# United States Patent and Trademark Office

Application Number: 10/009,696 Filing Date: November 06, 2001 Appellant(s): ARNOLD ET AL.

**EXAMINER'S ANSWER**

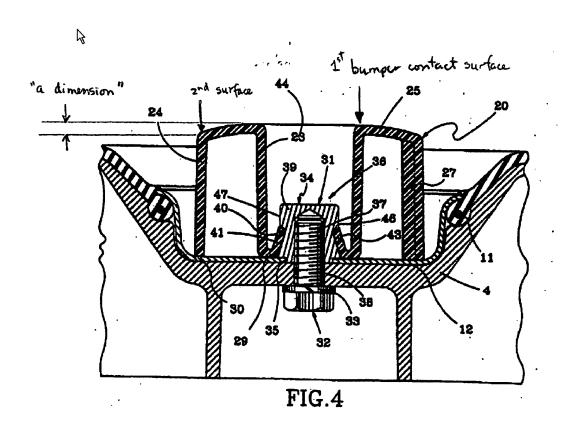
Re: claim 1, Ecktman et al. show an airspring, as in the present invention, comprising: a flexible cylindrical sleeve 10 secured at opposing ends, and first 2 and second 12, 20 retainers, the sleeve being secured at a first end to one of the retainers, and at the opposing end to other retainer as shown, the improvement being characterized by: one of the retainers 12, 20 having a bumper-contact surface, please see the marked up figure below, within the sleeve 10 for axial movement into the sleeve, the bumper-contact surface formed as a part of the retainer 12, 20 and which contacts the other retainer when the air spring is collapsed, and absorbs and transmits

Re: claims 2, 3 and 4, Ecktman shows support ribs 43,26, 27, 29, 30 wherein said ribs are substantially radially extending; and are a series of concentrically disposed.

Re: claim 5, Ecktman shows the first contact surface to be closer to the center corresponds to rib 29, the second contact surface to be further out corresponds to rib 30 and are separated by a dimension, please see the marked up figure above.

Re: claim 18, Ecktman shows the retainer 12, 20 extends into the chamber 15 and the axially outer surface to be closer to the center corresponds to rib 29, a separate axially outer surface to be further out corresponds to rib 30 and are separated by a dimension, see marked up figure above.

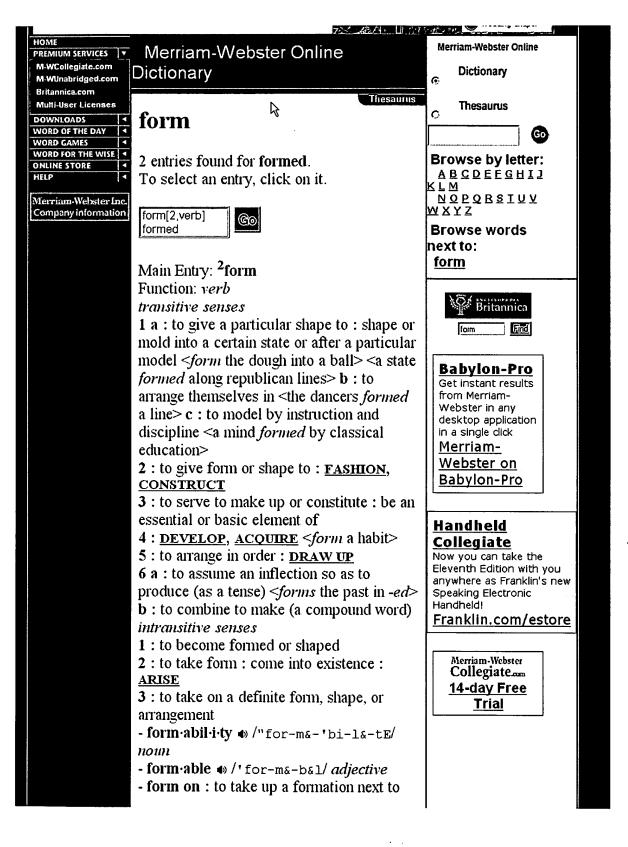
Appellant argues that Ecktman's bumper contact surface is not formed as a part of the retainer. Appellant provides support for this argument by giving examples of the term "formed" to be "cast, molded, formed or made as a single piece". The followings are definitions of "form" as a verb and "formed" as an adjective provided by Merriam-Webster Online Dictionary. Note that the 6b definition of the verb "form" is "to combine to make". The definition of the adjective "formed" would not be applicable for the instant invention since it involves living matter. Since the definition provides for a combination to make; element 20 and element 12 of Ecktman are combined to make a retainer to meet the claimed retainer 26 of Appellant. As combined, the bumper contact surface of Ecktman, as marked in figure 4 above is a part of the combined retainer.

Appellant further argues that Ecktman's element 12 does not enter the air chamber 15 and would not contact the other retainer 2 as claimed. Claims 1 and 16 claim a bumper contact surface to contact the other retainer. As shown clearly by Ecktman and as marked above, Ecktman's bumper contact surface is to contact the other retainer 2 to absorb the shock. Element 12 of Ecktman would not contact retainer 2 since it does not perform the function of absorbing shock. It is further noted in figure 2 of Ecktman that the bottom portion of sleeve 10 which encloses the air chamber 15 is

lower than the element 12. Hence, as shown element 12 has entered the air chamber

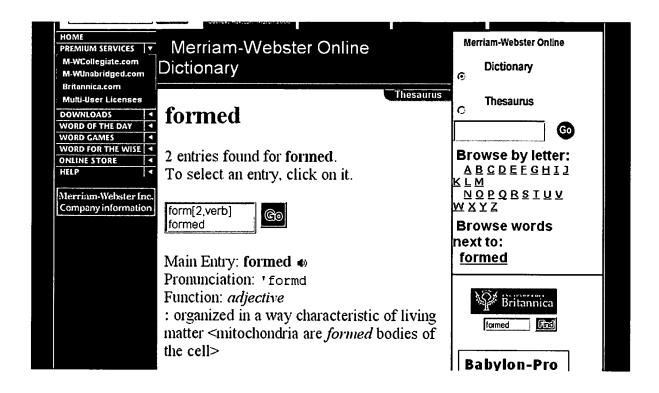
Appellant argues that the 103 rejection of claim 20 is contradictory to the 102 rejection of claim 16 because of the recognition of the bumper and the retainer of Ecktman to be two separate elements. Ecktman's elements 12 and 20 have been recognized as two separate elements in both the 102 and 103 rejections as stated in the Response to Arguments in the Office Action dated 9/2/05. It is maintained that Ecktman's retainer 12, 20 meets the claimed retainer in claims 1 and 16 because claims 1 and 16 do not specify the claimed retainer to be one piece and molded together as argued but not claimed by Appellant. Appellant further argues that it is not obvious to
